Core Operating Limits Report

Dresden Station Unit 3

Cycle 12

Revision 1

Figure 2.2-1
 MAPLHGR Limit vs. Bundle Average Exposure
 ANF 8x8 Fuel

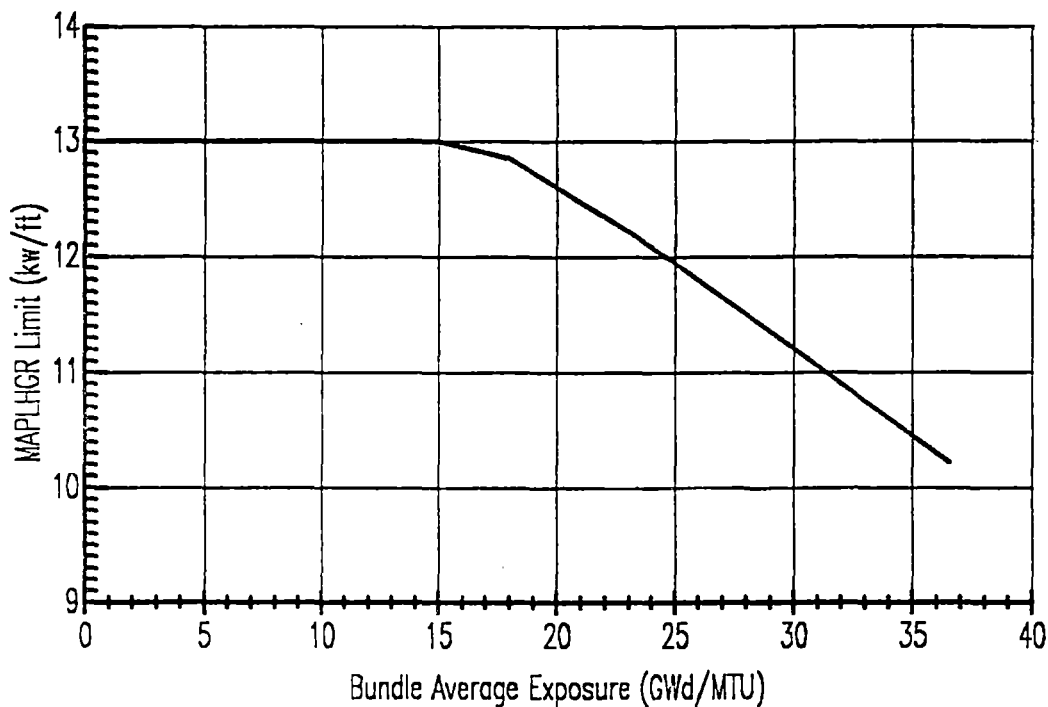
Affected Section	Affected Pages	Summary of Changes	Date
All	All	Original Issue	12/89
2.0	2-2	ANF 8X8 Exposure Extension	2/90
3.0	3-2	ANF 8X8 Exposure Extension	2/90
4.0	4-2	ANF 8X8 Exposure Extension	2/90

The above graph is based on the following MAPLHGR summary for ANF 8x8 fuel design.

<u>Bundle Average Exposure (GWd/MTU)</u>	<u>MAPLHGR Limit, Kw/ft</u>
0	13.00
10	13.00
15	13.00
18	12.85
20	12.60
25	11.95
30	11.20
36.5	10.22
